**Joint Regional Planning Panel
(Sydney East Region)**

JRPP No.	2016SYE031
DA No.:	DA/39/2016 – Stage 2 DA for Lot 2 to construct part 2/part 3 storey multi-dwelling housing development with roof terraces, containing 33 dwellings, basement parking for 50 vehicles, at grade parking for 8 vehicles, landscaping and associated works at 5-15 Cawood Avenue, Little Bay.
Applicant:	TA Little Bay Pty Ltd
Report By:	Development Assessment Officer – Randwick City Council

Figure 3: Site plan showing bounded in red the general location of the basement level underneath.

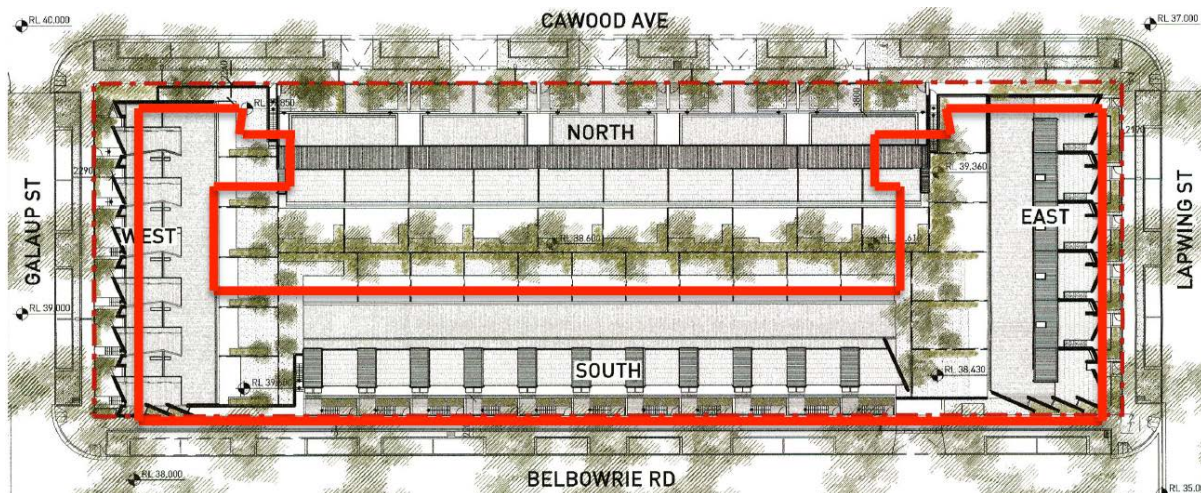
The basement level protrudes above the remediated ground levels by varying degrees. The parking provided on site contains provisions 8 ground level parking spaces for the 8 attached dwelling terraces facing Cawood Avenue, in the basement level 50 parking spaces are provided two each for the terraces located over basement. No bicycle or motorcycle spaces are shown. Vehicular access is proposed from the south eastern end of the site off Belbowrie Road.

FIGURE 3 – BASEMENT PLAN EXTRACT

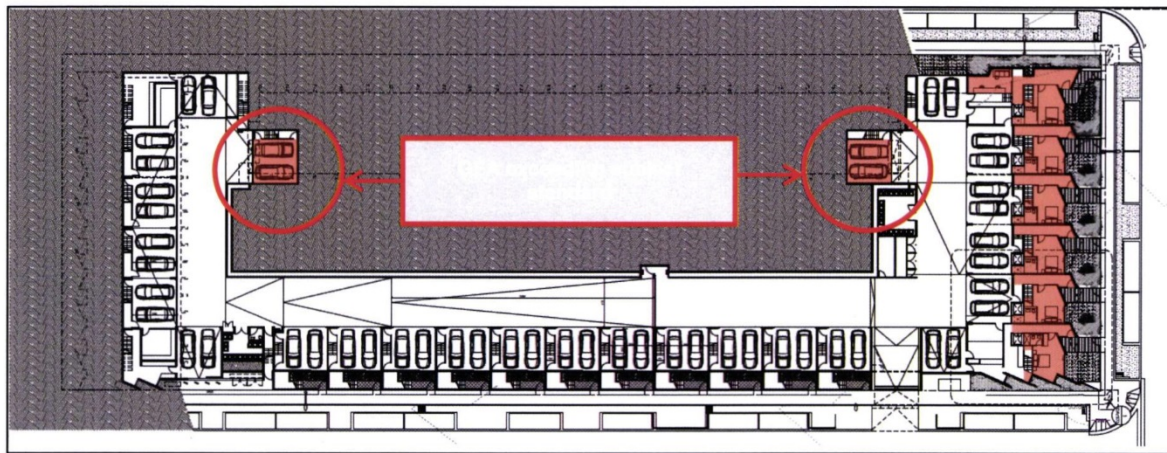
It has always been the intent that Lot 2 would comprise terrace house style dwelling, with each dwelling having access to its’ own independently accessed double garage below. While dwelling houses are required to provide 2 car parking spaces, the combined basement of much of the proposed design results in many of the proposed dwellings technically being defined as residential flats, which are only required to have 1.5 car parking spaces per dwelling. It is nevertheless proposed to still provide 2 car parking spaces per dwelling, resulting in 4 more spaces than required. Under the revised provisions of the Randwick LEP 2012, these spaces equate to a GFA of 52m², as they are not necessary to comply with Council’s requirements.

The additional 4 car parking spaces contributing to GFA are illustrated in the following **Figure 3**.
